Re: Kohler Golf Course NOI

On behalf of Kohler Company, Excel Engineering is submitting the following responses and/or additional information you requested in your February 6, 2018 email. Our responses are provided in the order presented in your email as follows.

**KOHLER COMPANY
PROPOSED GOLF COURSE
CITY OF SHEBOYGAN, WI**

January 17, 2018
REVISED February 26, 2018

AREA 1
MAINTENANCE BUILDING

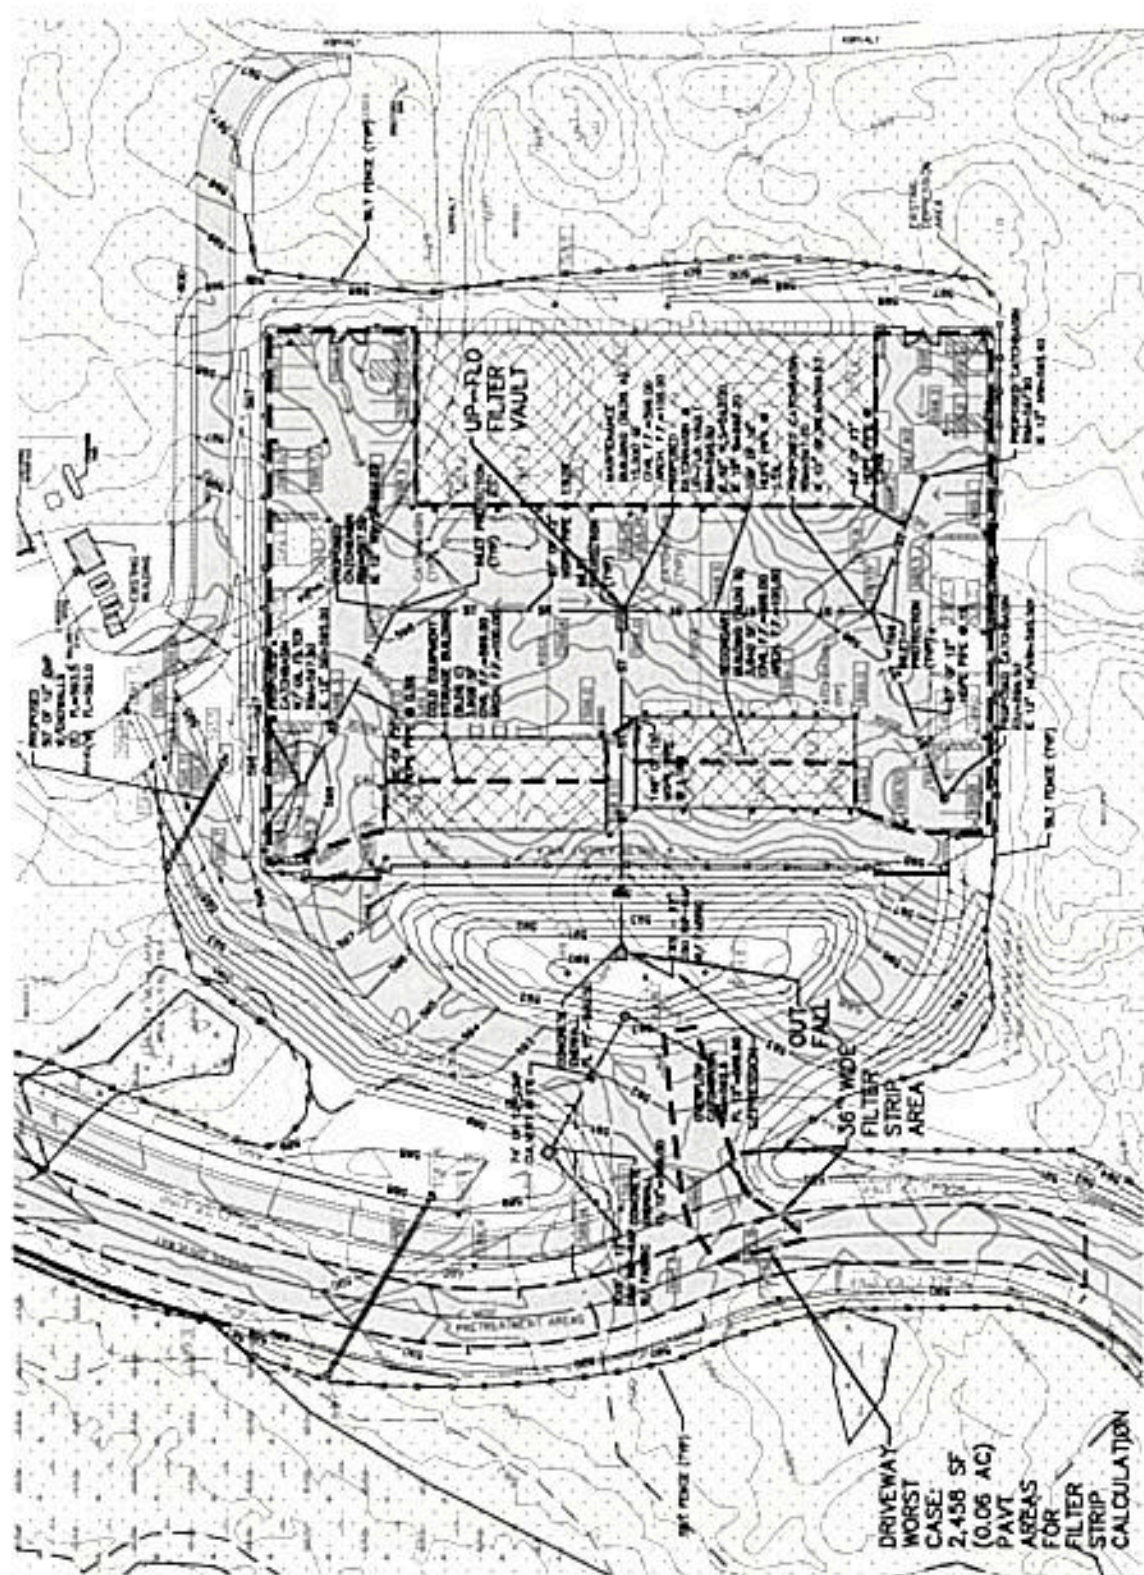
- Please clarify what filter strips will receive runoff based upon the proposed access road grades – Please see Appendix G where the drainage area tributary to the proposed Up-Flo Filter is delineated as well as the drainage areas around the access drive. A worst case drainage area that is tributary to the proposed filter strips is also shown and discussed further below.

Appendix L
Area 6 – Total Development and Depression Area Map
and Calculations:

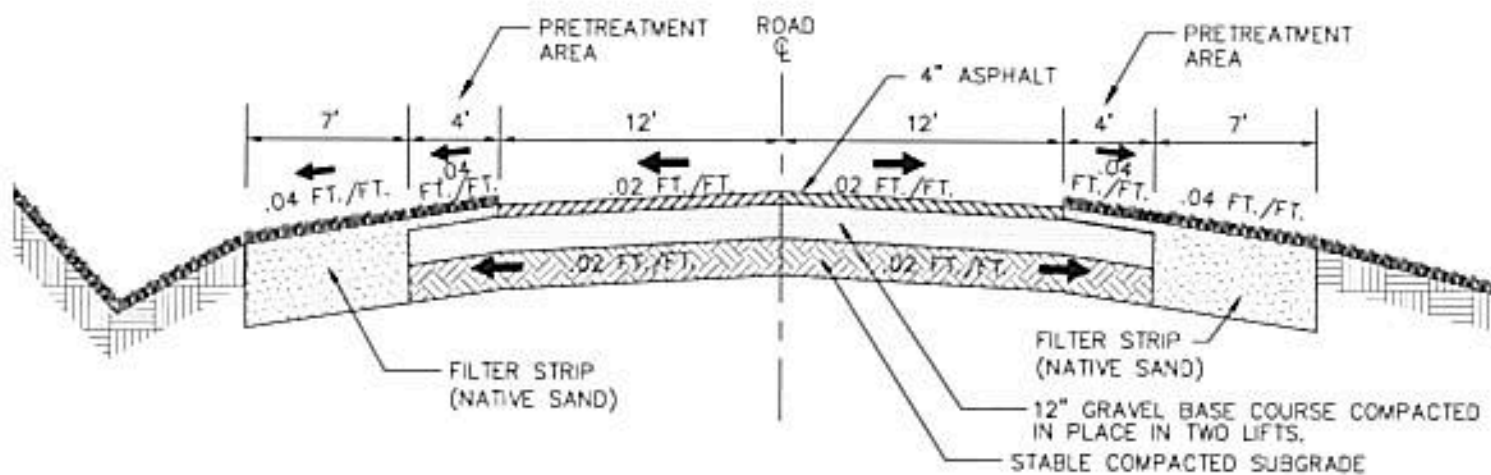
- Show that NR151 peak discharge rate requirements will be met – In consultation with Pete Wood, Excel ran a WinSLAMM analysis for the entire developed area including the effects of the depression areas (depicted in Appendix L) using the Milwaukee 6392.rain file. This rain event exceeds the 2-year, 24-hour storm volume analysis required by the DNR. The SLAMM analysis shows no runoff will occur during the analyzed rain event. This is detailed in Section IV (f) of the revised storm water management plan report.
